HECA Water Workshop

08-AFC-8A

Groundwater Flow Model Discussion Technical Points

Model domain (100 by 100 Miles), finite-difference discretization, and BC
(in Model Layer 1 – Unconfined 0 to 300' bgs)

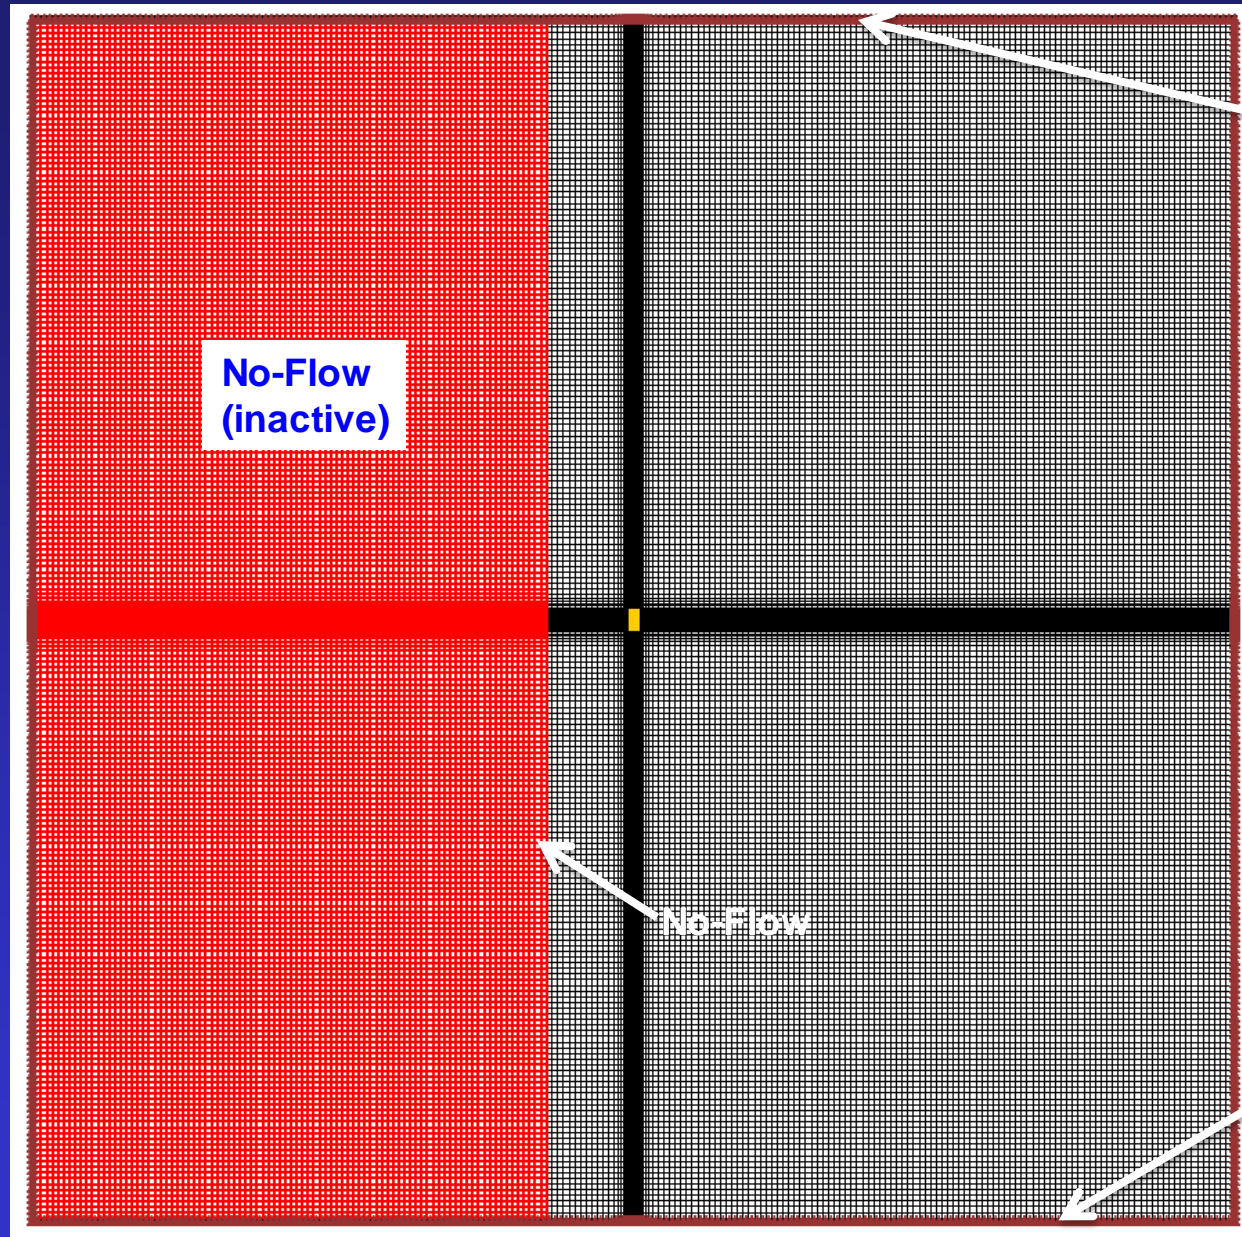
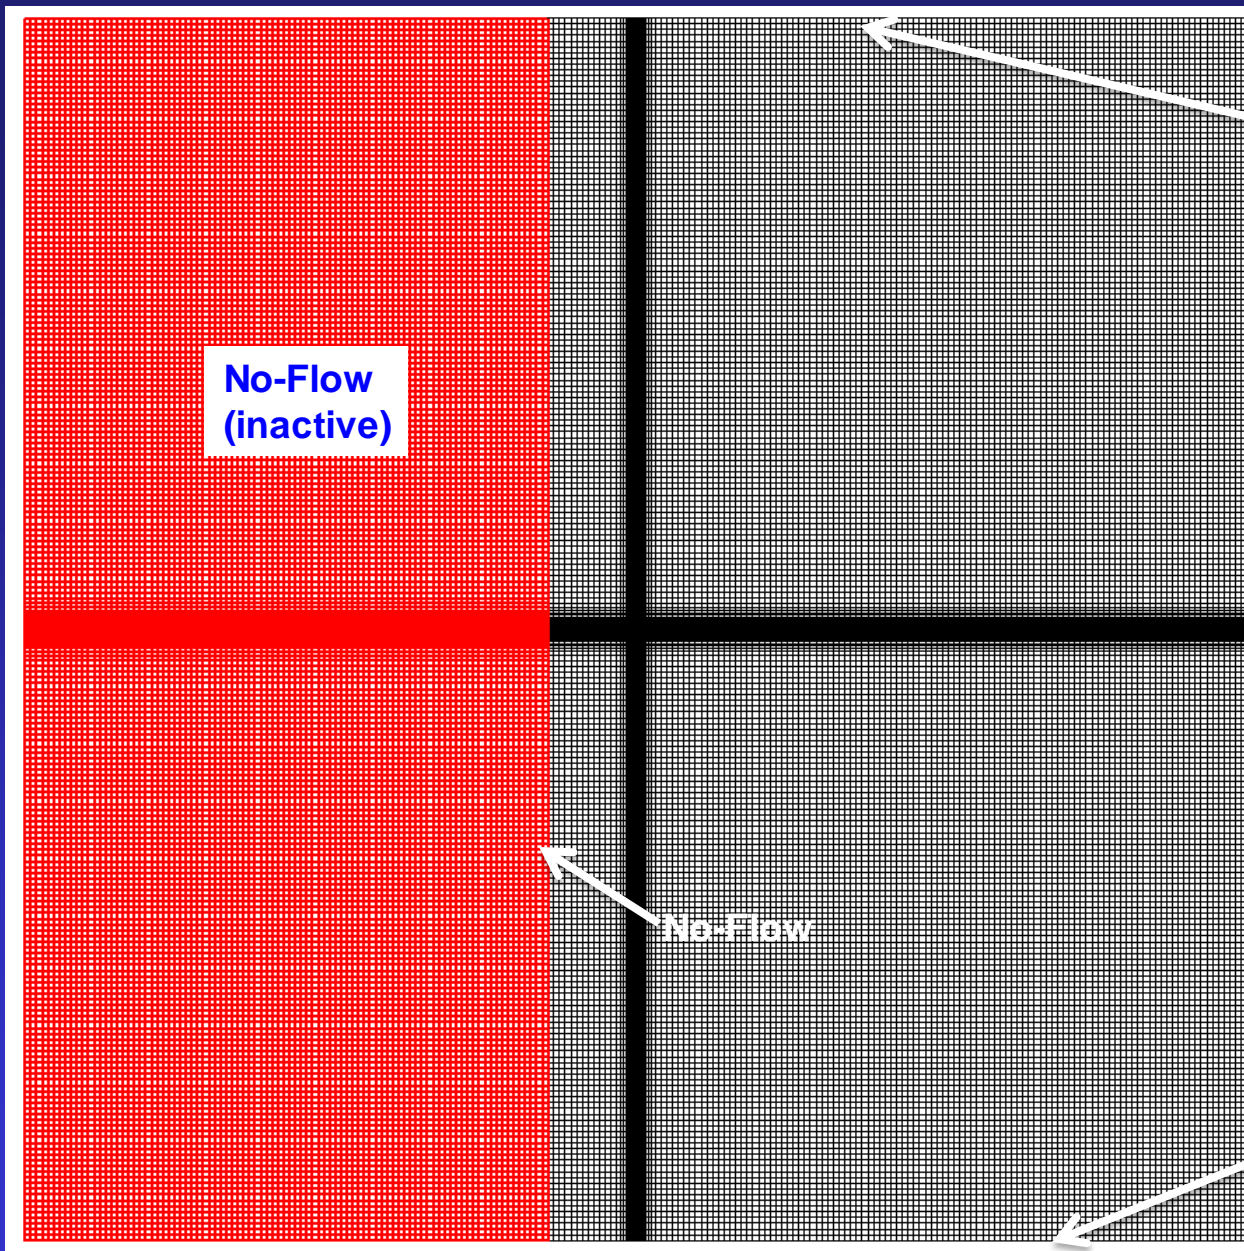
URS	CEC
Model Value	General Head (all 4 sides)	No Flow (Western Boundary)
Rationale	<p>Model domain is 100 x 100 miles, which far exceeds the project well field pumping influence. Therefore, the model boundary does not have an effect on groundwater response in the project area.</p>	<p>To represent the contact between the water bearing alluvium and essentially non-water bearing marine rocks of the Coast Ranges. Contact is ~6 miles west of the project well field.</p>

Specific Yield

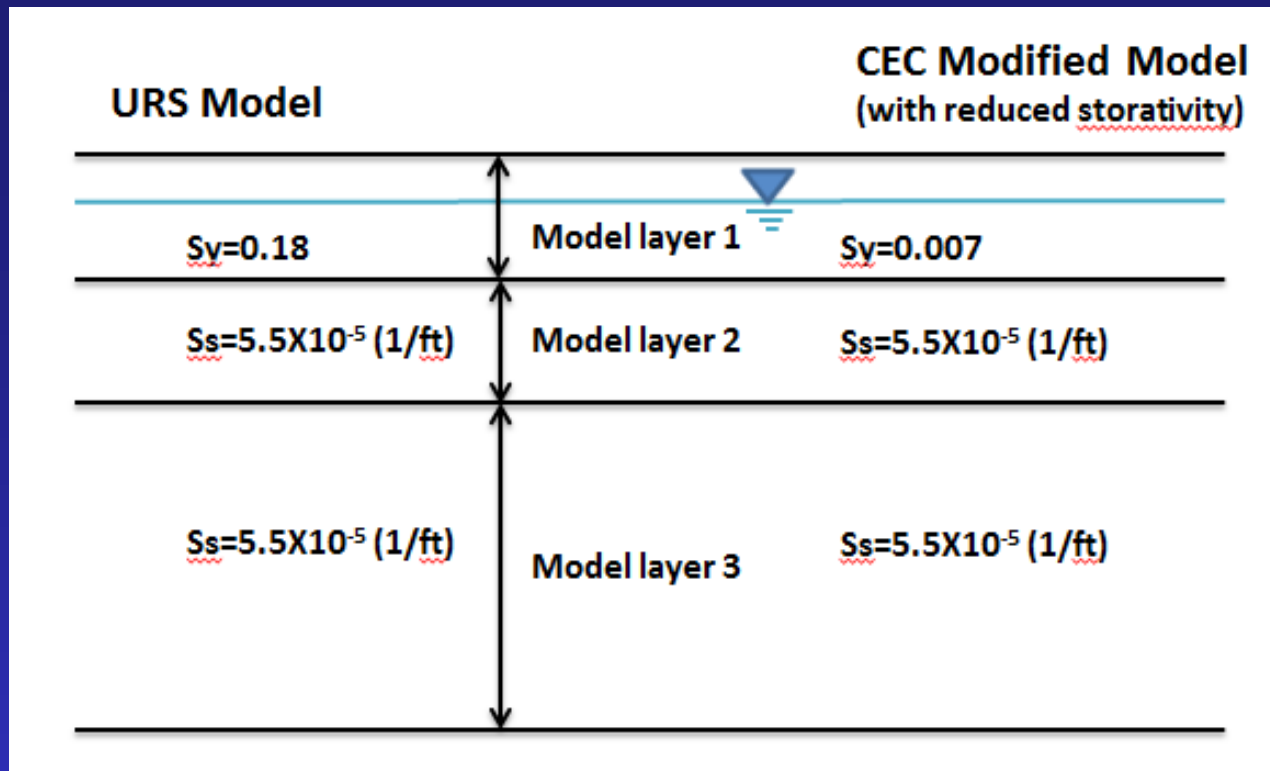
URS	CEC
Model Value	0.18	0.007
Rationale	<p>Based on information from Sierra Scientific Services, specific yield of the local aquifer system ranges from 0.15 to 0.20. This is typical for an unconfined aquifer. A mid-range value was used in the model for the Base Case, noting that sensitivity analysis were also run and provided in the AFC GW Model Appendix (N-2 in May 2012 and O in May 2009)</p>	<p>Geometric mean of storage coefficients from URS' aquifer test analyses.</p>

- In MODFLOW, specific yield (S_y) is always used in the model layer containing the water table (unconfined). It is not appropriate to apply as S_s value to an unconfined condition.
- In MODFLOW, specific storage (S_s) is always used for model layer where water table is above the layer's top elevations (confined).

- CEC's use of 0.007 is inappropriate for the top, unconfined, model layer (0 to 300' bgs with water table ~50' bgs).
- As stated in HDAR findings, the distribution of storativity values is bimodal: some wells had lower values some wells had higher values. Therefore, use of 0.007 to represent top model layer (unconfined) is inappropriate.
- Sy of 0.007 is not supported by what BVWSD has observed with long term agricultural well pumping. If it were 0.007, the aquifer system would have been dried out by now. As such the CEC modification is not realistic or usable when trying to approximate local aquifer conditions.

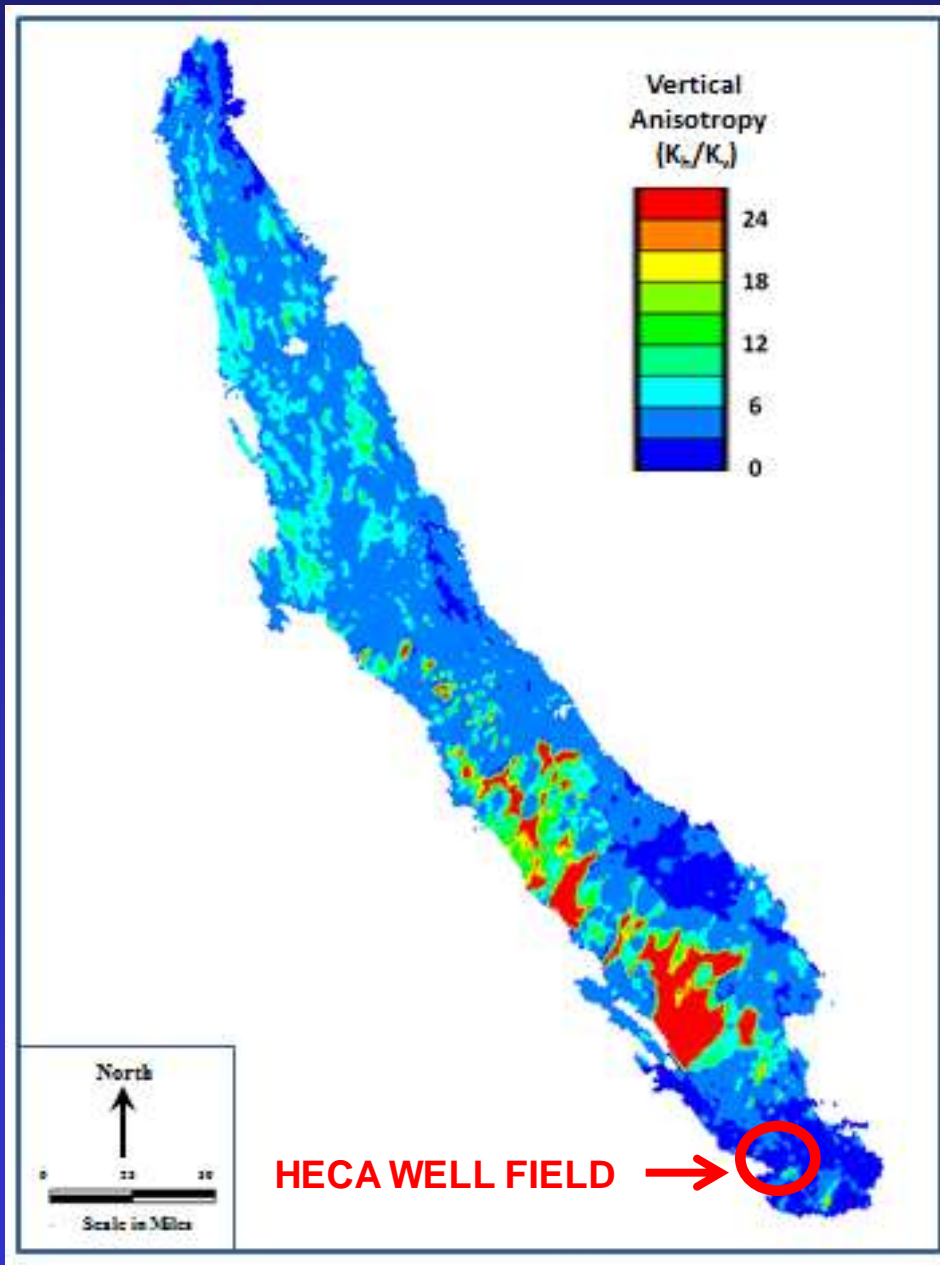
URS	CEC
Model Value	30	1,000
Rationale	Typical range is 10 to 50. A mid-range value was used for the Base Case.	Based on Belitz and others (1993)

- Belitz and others (1993)
 - Study area is in northern Fresno County, ~150 miles north of the project site, thus is not necessarily correlatable to the BGRP/HECA study area.
 - The CEC model modification assumes the presence of a Corcoran Clay equivalent (CCE). Local geologic and geophysical logs do not support CCE presence. When observed clay lenses appeared to be of limited extent (not laterally continuous) and thicknesses most a depths of ~600 to 700 feet bgs.

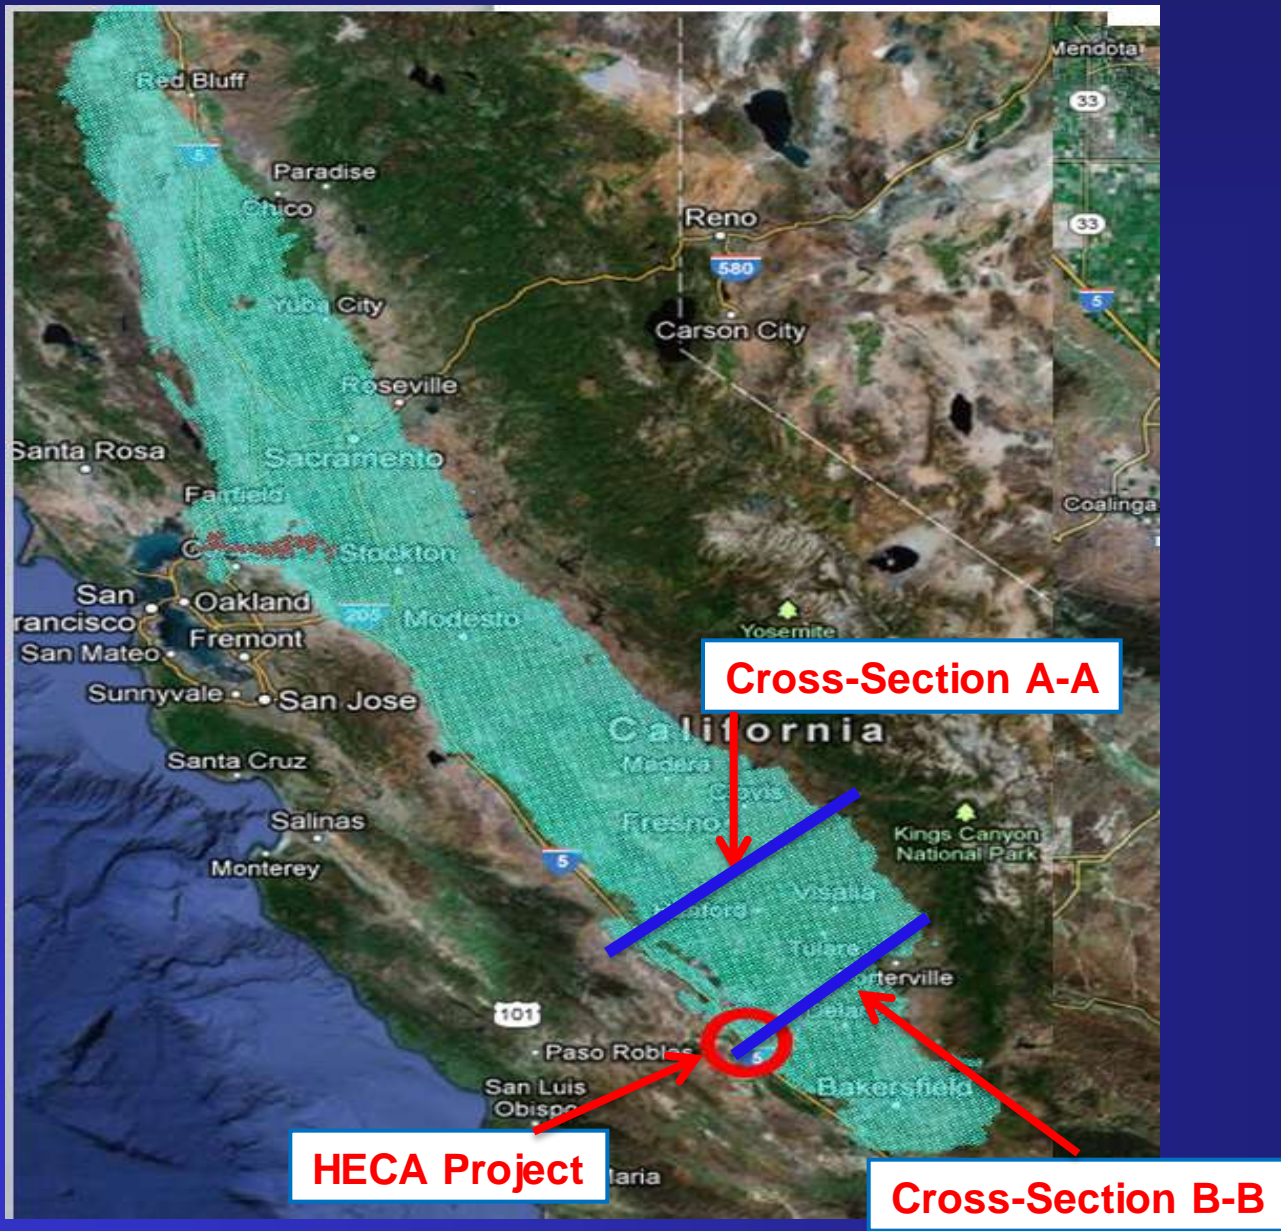
- USGS CVHM Model (2009)
- Maximum Anisotropy ~27
- Anisotropy in the vicinity of the HECA well field <10

Model layers at cross-sections A-A' and B-B'

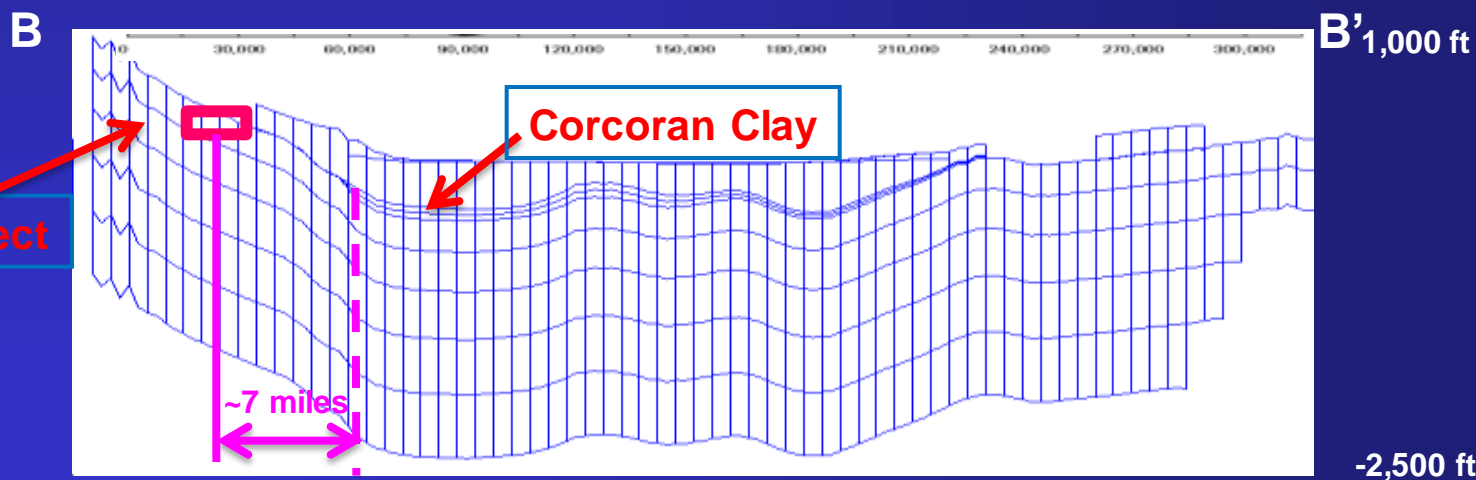
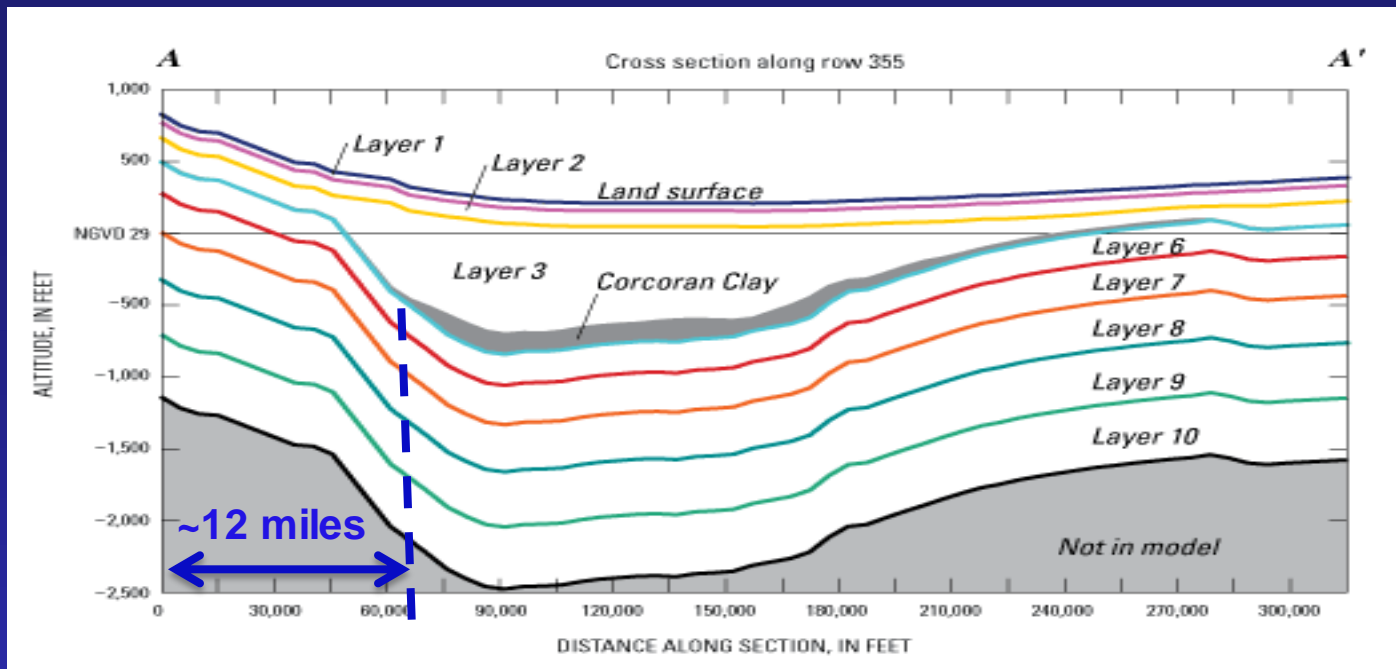
Note:
Corcoran clay is absent underneath HECA project (~7 mile away)

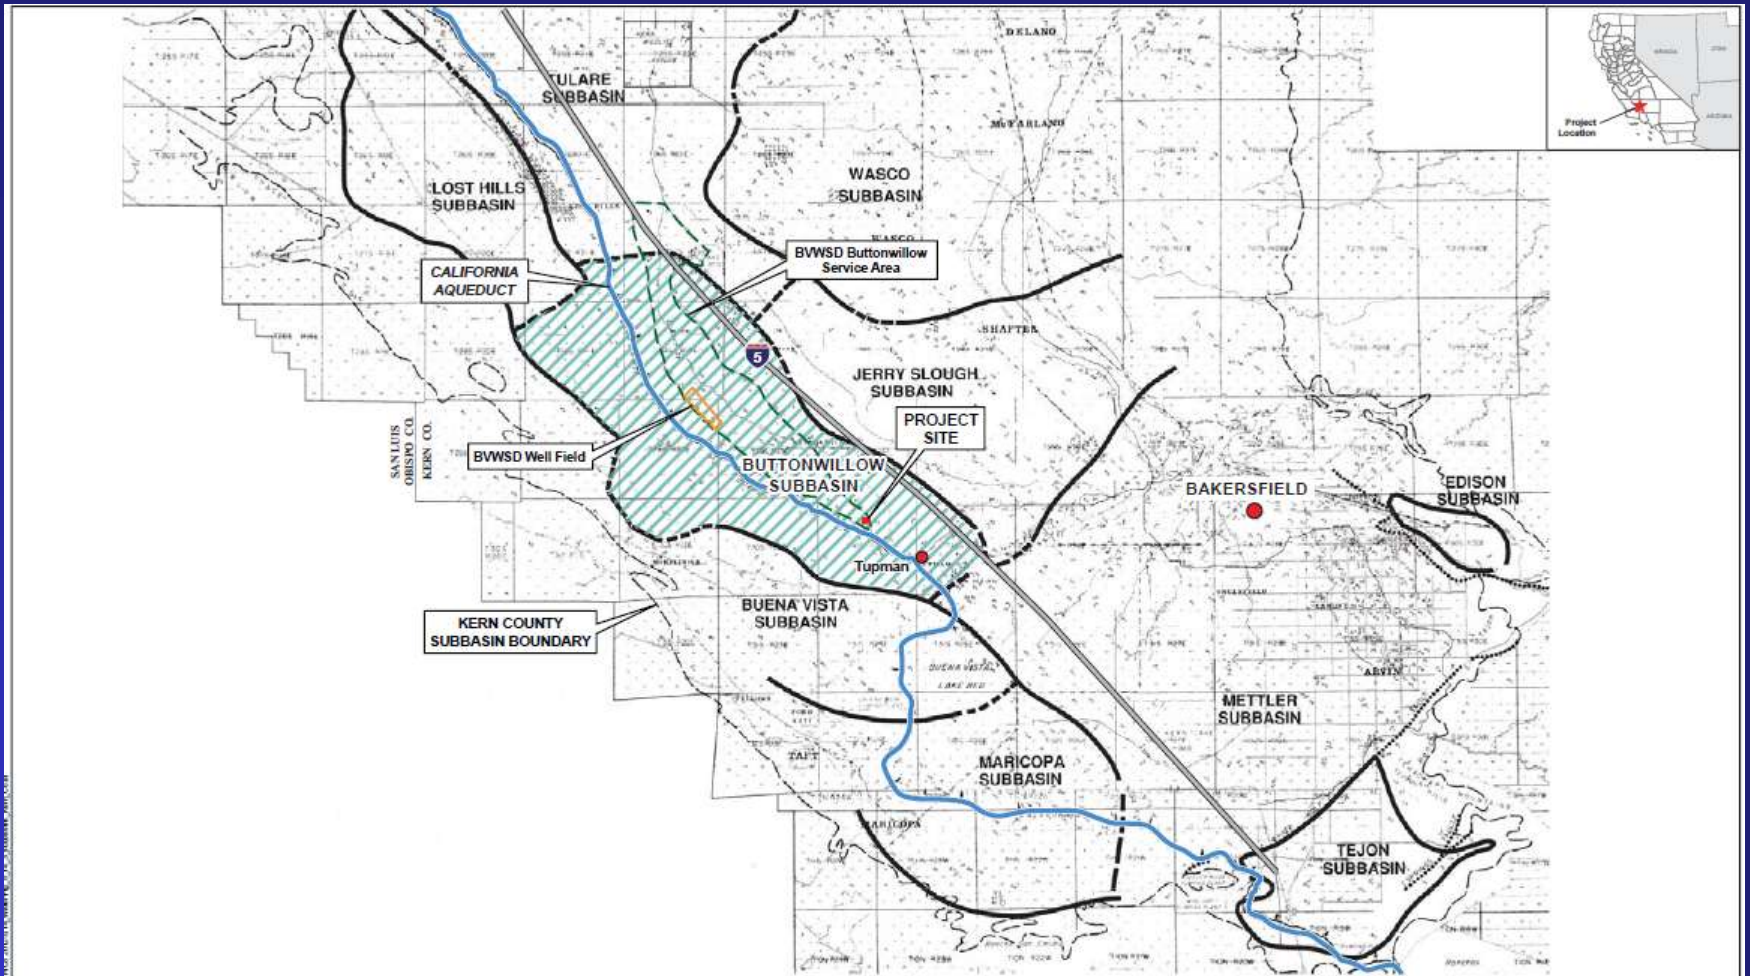
- CECs selection of an anisotropic ratio of 1,000 is poorly justified and not remotely close to the hydrogeologic conditions in the study area.
- The CEC suggested anisotropic ratio forces an extreme condition simulating drawdown and drawdown geometry that is erroneous and misleading . This led to incorrect calculated impacts.
- BVWSD observations on how their GW system has responded to agricultural pumping (volumes far greater than BGRP 7,500 afy) verify that CEC selection of an anisotropic ratio of 1,000 is not valid.
